# OCP Amendment & Rezoning Application for 900-Block and 1045 Yates Street &

Development Permit with Variances Application for 1045 Yates Street

# July 15, 2021 Committee of the Whole

# Accessible Units

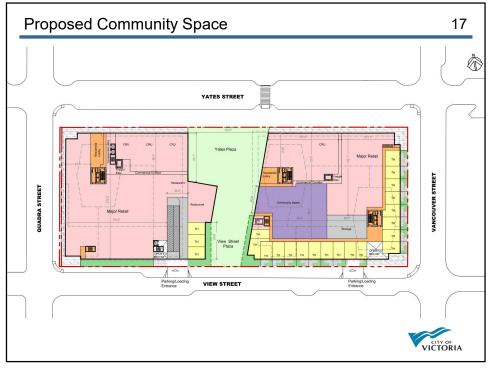
"5% accessible units across all phases of the development"

- 5% of the units would meet adaptability standards as per the BC Building Code (BCBC).
- Includes dimensional requirements in washrooms, corridors and doorways and locating switches at an appropriate height.
- Commitment to paying for additional costs associated with retrofits required to meet individual renter accessibility needs.

# Parking Variance

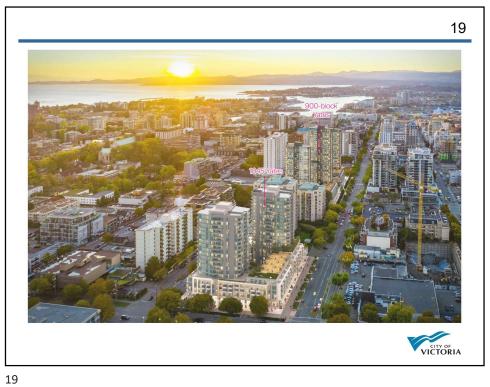
# Changes since July 15

- Required amount of residential parking has reduced from 316 to 282
- Variance for residential vehicle stalls has reduced from 48 to 9
- Variance for residential vehicle visitor stalls has reduced from 40 to 32
  - 13 residential
  - 17 commercial
  - 2 daycare
- Variance for 11 bicycle parking stalls (10 long term and 1 short term) – expectation that this will be rectified in future plans
- Reduction in Transportation Demand
  Management (TDM) programs from three car
  share vehicles and three car share stalls to two
  car share vehicles and two car share stalls.
